CHANGE NOTE FOR SOFTWARE v30_xx_b07/v02_xx_b08		
	<b>6000HP 9 and 5 MODULE POWER CONVERTER</b>		
	<b>CODE: AA.58.V0.3021</b>	<b>EDITION: 30_xx_b08</b>	Pag. 4 of 33

This document summarizes the purpose and the new features of the Software Version 30\_xx\_b08<sup>2</sup> for the project 6000HP 9 Module Power Converter Locomotive and SW version 02\_xx\_b08 for the project 6000HP 5 Module Power Converter Locomotive. This is released as per the feedback from previous SW v29 of 9 Module Power Converter and SW v01 for 5 Module Power Converter.

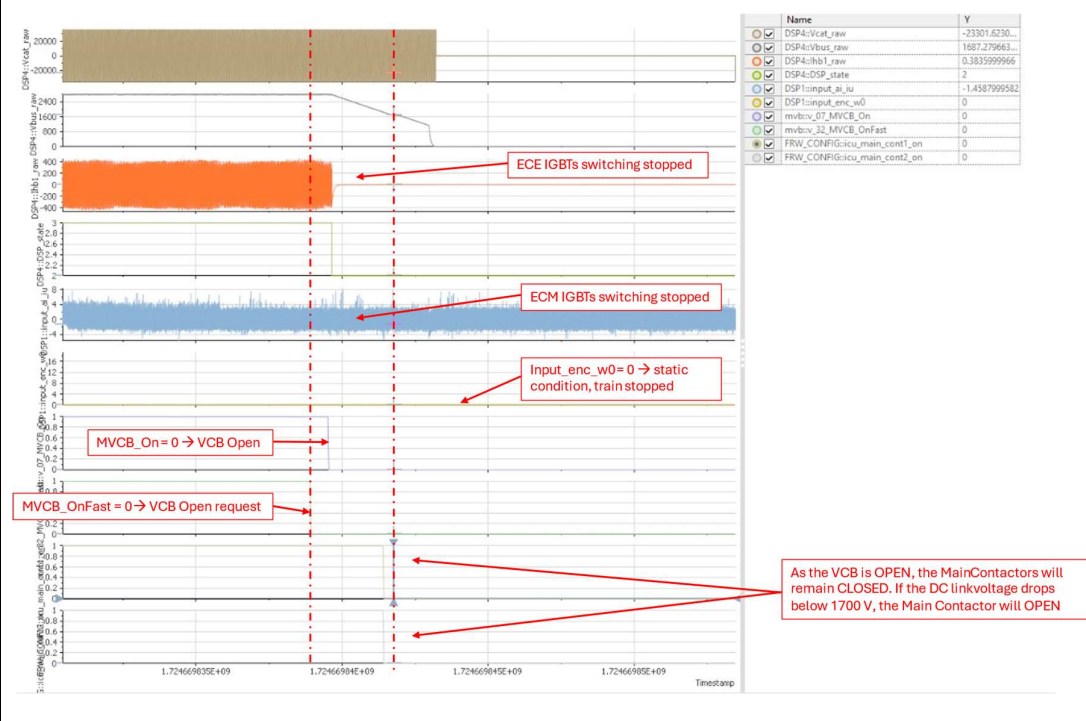
Neutral Zone management change

As a result of the validation of previous SW versions (29 and 30\_b04), customer and CG requested to implement the same logic that is implementing for Neutral Sections also when driver opens the VCB in static condition:

The speed limitation of 1 m/s (3.6 km/h) is erased from the Neutral Section management logic so in both static and running conditions, as soon as the driver requested to open the VCB, the ECE and ECM IGBTs switching will stop, the contactors will REMAIN CLOSED, and the DC link will start discharging through the Permanent Discharge Resistor (RDP). If the DC link voltage drops below 1700 Vdc, the contactors will open to prevent high inrush current peak when the VCB is reconnected.

The behavior is evaluated in the HIL environment successfully:

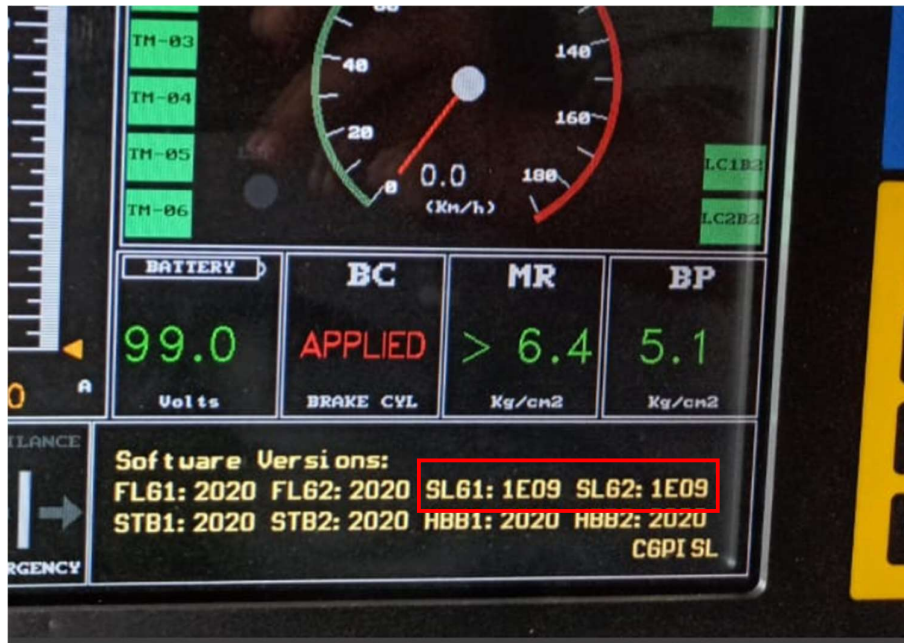
As per request of IR, the SW version identification has been changed to show clearly into the HMI the SW version uploaded as long as the Loco Type identification:

As per the new identification format, the major of the SW version (first two digits) will be used for SW version identification itself (v29, v30, v31, etc.), while the minor (last two digits) will be used for Locomotive Type identification (WAG9 = 09, WAP7=07 and WAP5=05).

The same is tested in a WAG9 locomotive in Rourkela shed:

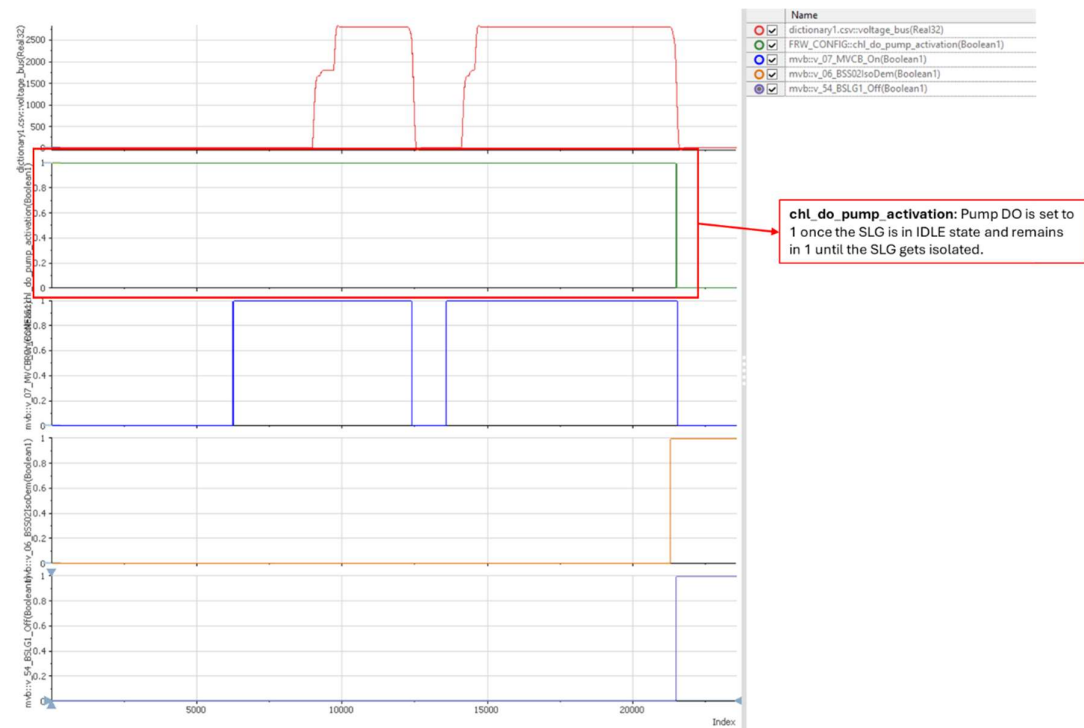
Converter Liquid Pump DO management

It is detected that with SW v29 the Converter Cooling System pump DO is commanded to switch ON and OFF every time the VCB is open/close. The multiple number of switches is generating stress to the cooling pump contactor that is leading to failures.

The pump DO command logic is change as per Royapuram shed's request:

- If SLG in IDLE state → Pump ON (FLG Node <504)
- If VCB Off → Pump ON
- If SLG Isolated → Pump OFF

The same was evaluated in the HIL environment:

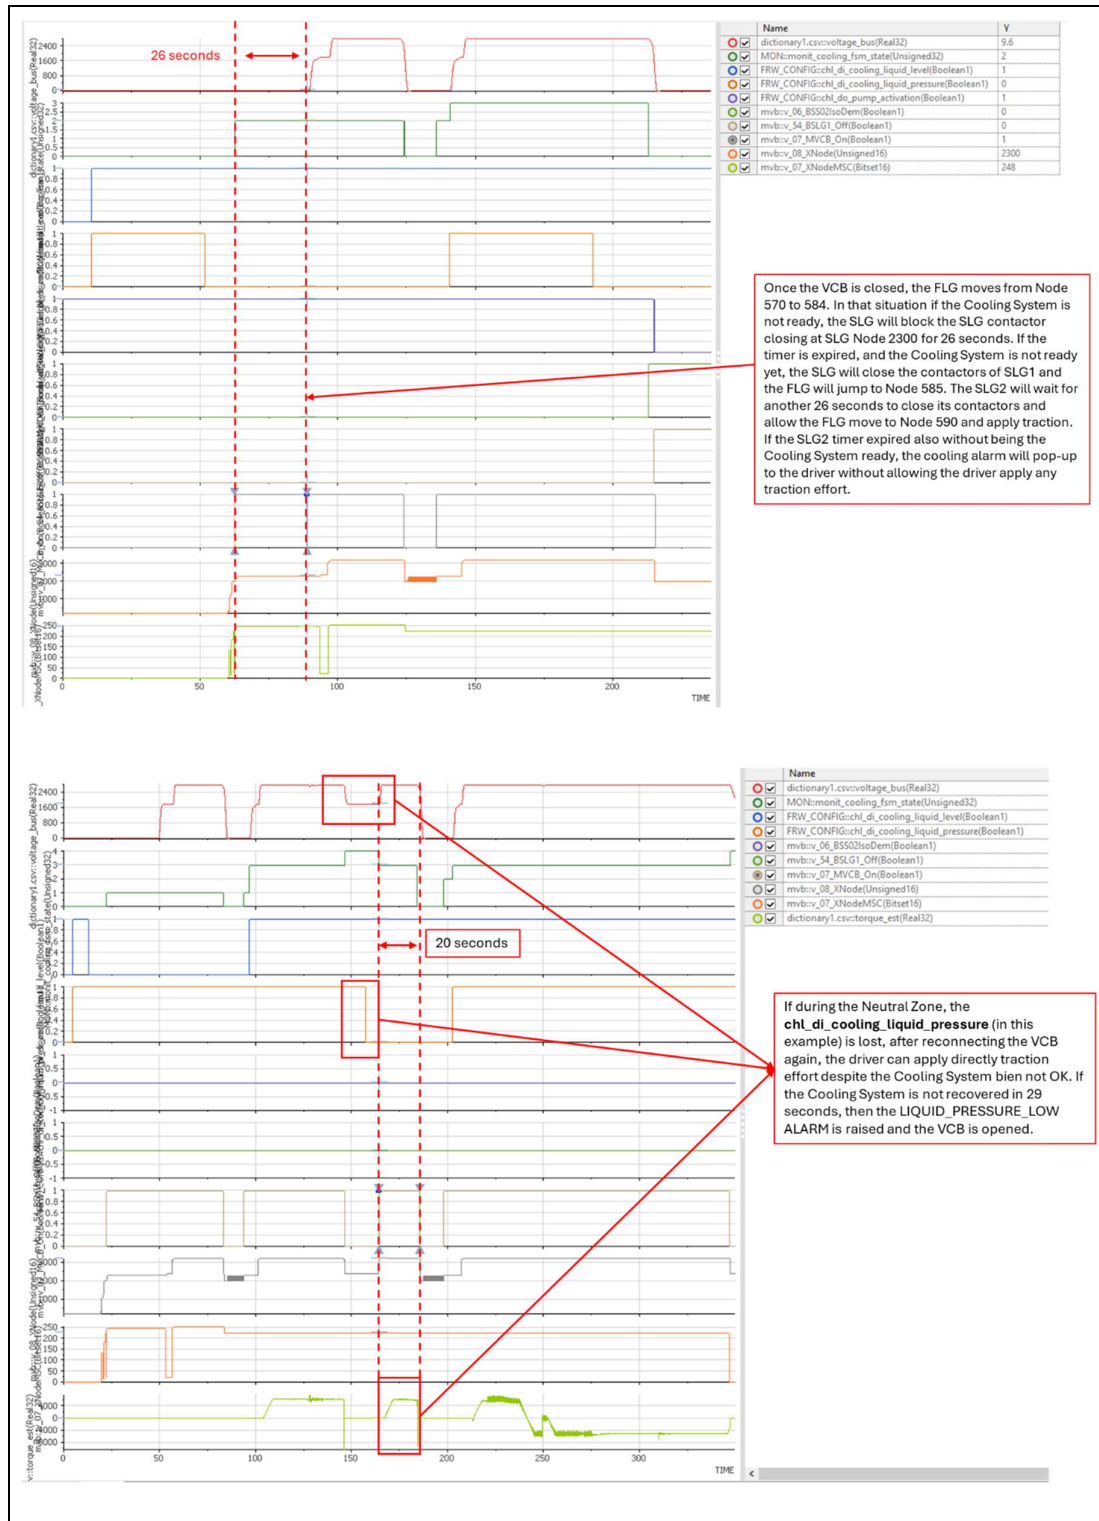
MOTOR ISOLATION due to Cooling Evaluator problems

In some sheds, it is detected that if the Cooling System is not ready and the driver moves the throttle to forward position (usually 9 seconds after the VCB is closed) to apply traction effort, the SLG is getting isolated due to ALL MOTORS ISOLATION alarm. Once the VCB is closed, if the Cooling System (Cooling level or Cooling pressure) is not ready, the alarm WARNING\_COOLING\_SYSTEM\_NOT\_READY is active in Traction Logs. Being the alarm active, if the FLG commands to apply traction effort, the alarm ALL MOTORS ISOLATED is pop-up to the driver isolating the corresponding SLG.

The SLG contactor closed at FLG Node 584 (SLG1) and 585 (SLG2) has been conditioned to the Cooling System ready status. This means that if the Cooling System is not ready when the driver goes from Node 570 to 590, the SLG will block the contactor closing at Node 584/585 to prevent apply any traction effort in that situation.

To avoid the FLG alarm of Converter Contactor Timeout if the Cooling System is not becoming ready after the FLG commands the contactor closing in these nodes, a timer of 26 seconds is added also to the conditions as if the timer is expired but the Cooling System is not ready yet, the FLG could move to Node 585 without giving any error.

The same logic is implemented in node 584 (For SLG1) and Node 585 (for SLG2). With this, if the Cooling System is not ready in 52 seconds, the alarm of LIQUID\_PRESSURE\_LOW or LIQUID\_LEVEL\_LOW will rise before the driver can reach Node 590.

The same was evaluated in the HIL environment:

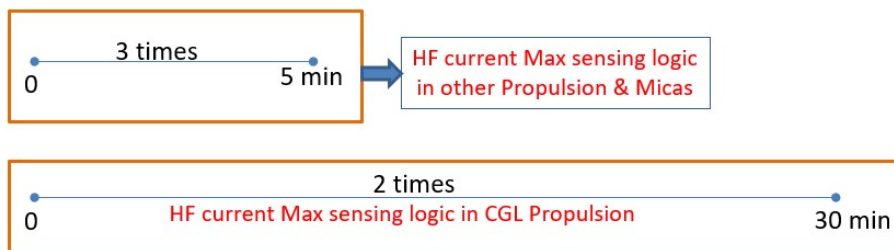
SLG Isolation due to Harmonic Filter Overcurrent alarms

On Royapuram shed, it is detected that if the Harmonic Filter Overcurrent alarm is detected twice in less than 1800 seconds, then the corresponding SLG harmonic filter is isolated, and the speed is limited to 40 kmph. The activation of this alarm could be normal after raising the pantograph and/or closing the VCB due to magnetization current through the transformer winding or due to a high harmonic frequency component in the AC catenary.

The proposal is to change the alarm management so that if the alarm is detected three times in less than 5 minutes, then the harmonic filter would be isolated. This management could help to better differentiate a critical over current situation (real problem on the harmonic filter) to the non-critical sporadic events and increase the field availability.

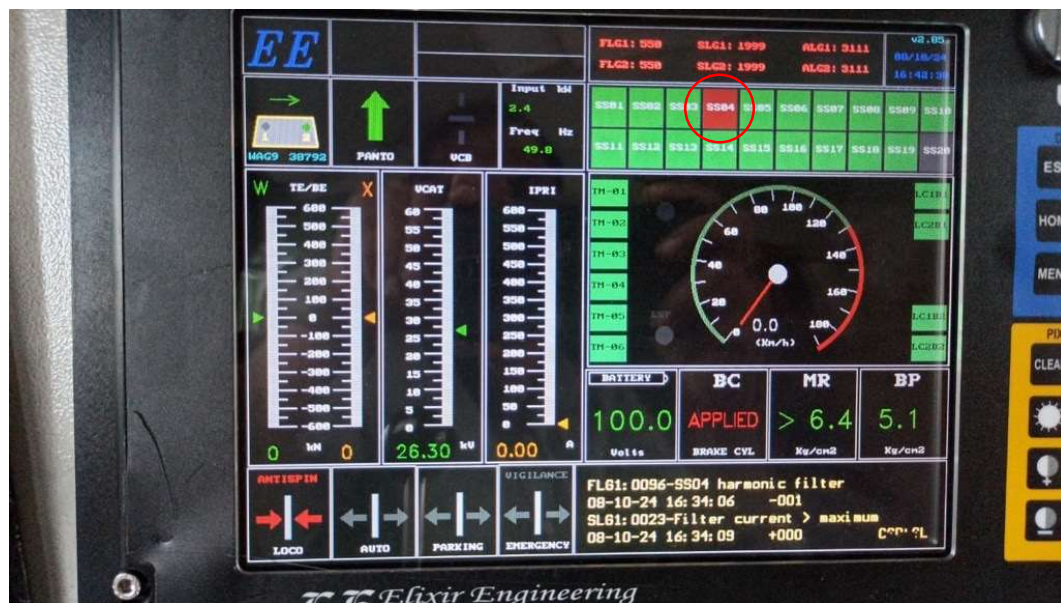
The Harmonic Filter Overcurrent alarm management is changed.

This behavior has been evaluated on field service at Rourkela shed:

### - Non – Critical IGBT error - Slave Inverter (TCC1, TCC2) → UP to ISOLATION

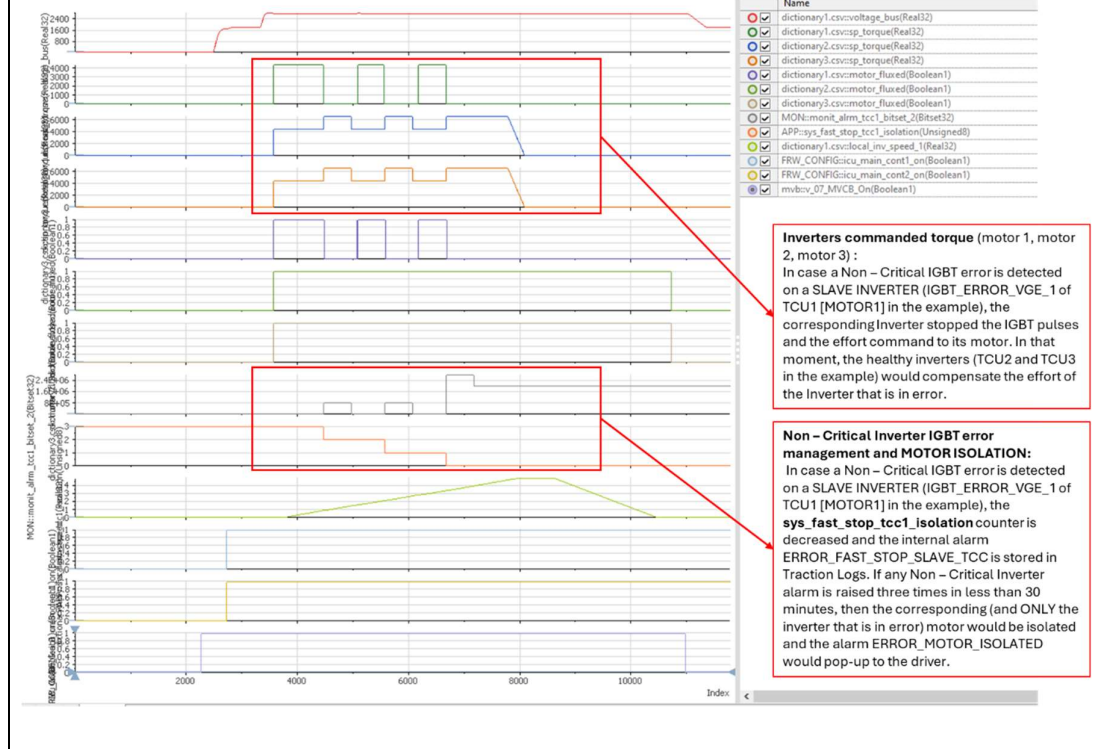
The IGBT errors and the corresponding alarm management has been segregated to Critical IGBT errors and NON-Critical IGBT errors as follows:

To increase the field availability, the IGBT error management has been changed as per a Non – Critical IGBT error only would isolate the part of the SR that is generating the error leaving the rest of the converters on the same SR available to apply traction.

The behavior of the system has been evaluated in the HIL environment for all the possible situations:

- **Non – Critical IGBT error - Rectifier → Up to ISOLATION**

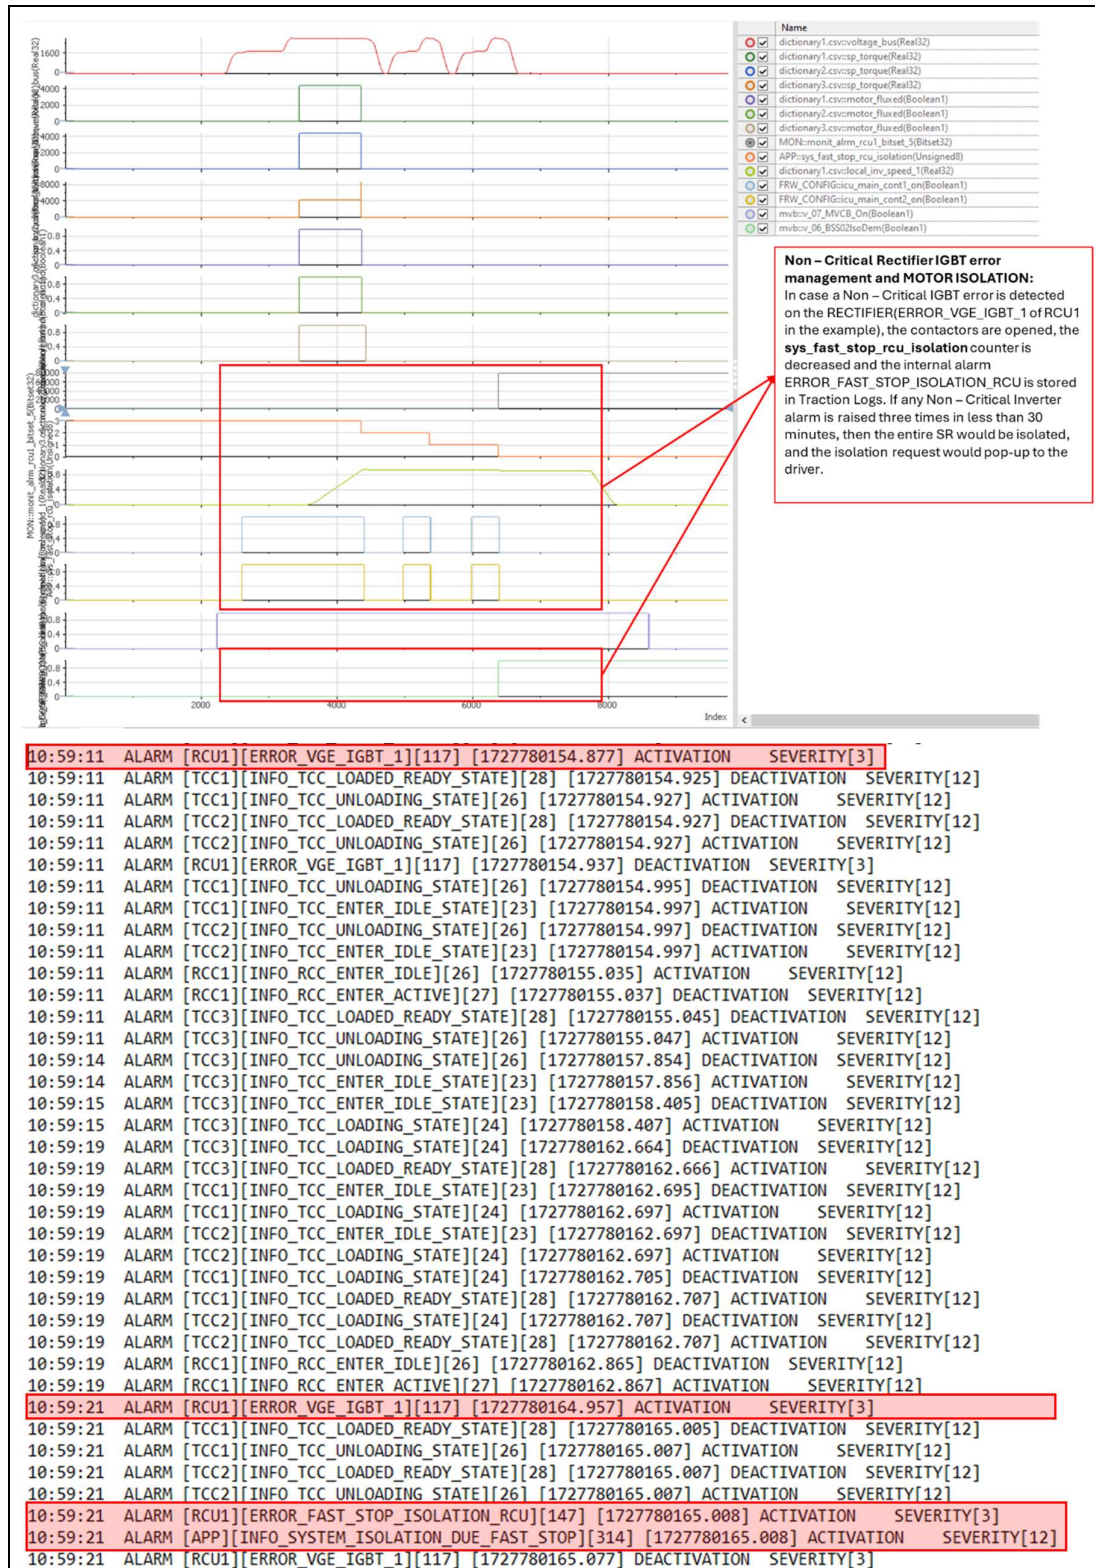
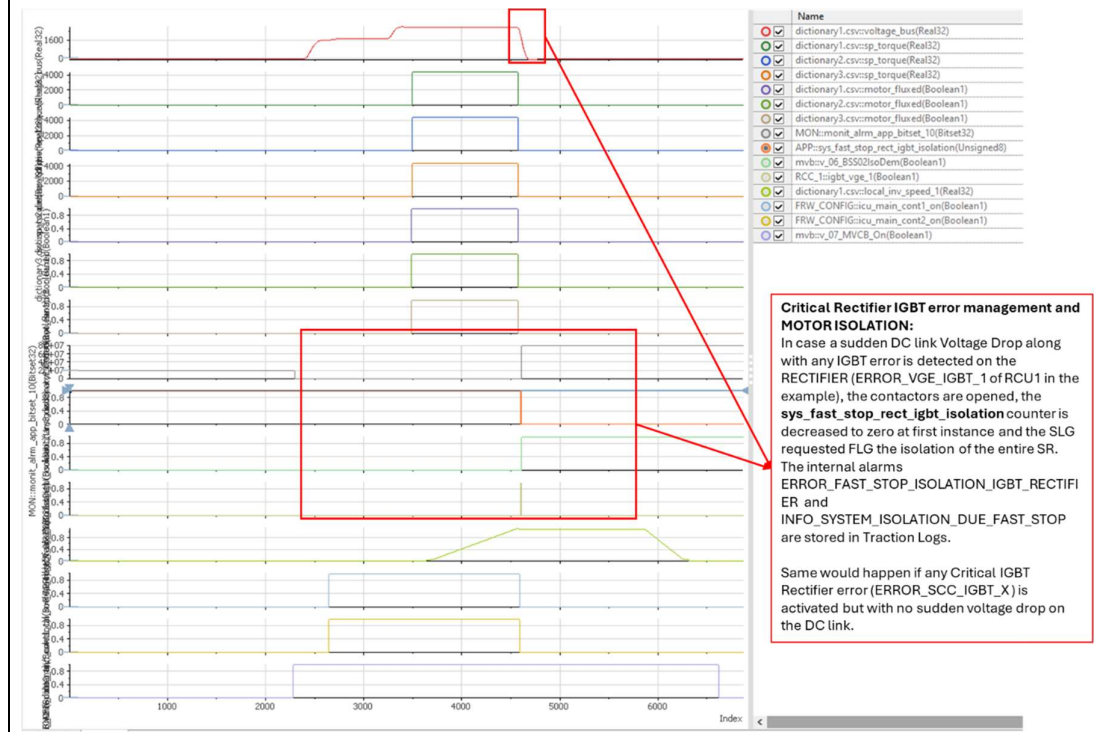
In the case explained above, as the rectifier got isolated due to the multiple activation of Non – Critical IGBT alarms, the entire SR should be isolated as the rectifier control is needed to supply the traction motors.

### - Critical IGBT error – Rectifier → Up to ISOLATION

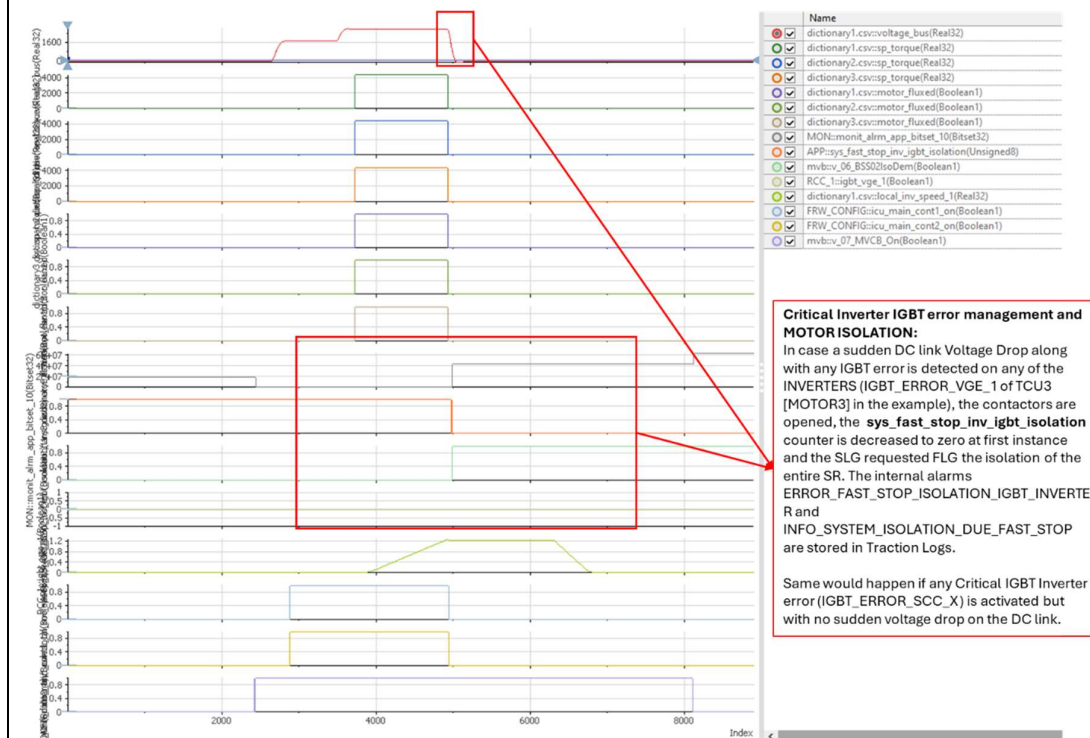
To detect and segregate the critical IGBT error blast situation from the non-critical situation, a new DC link Voltage drop detection is added also to detect a DC link short circuit.
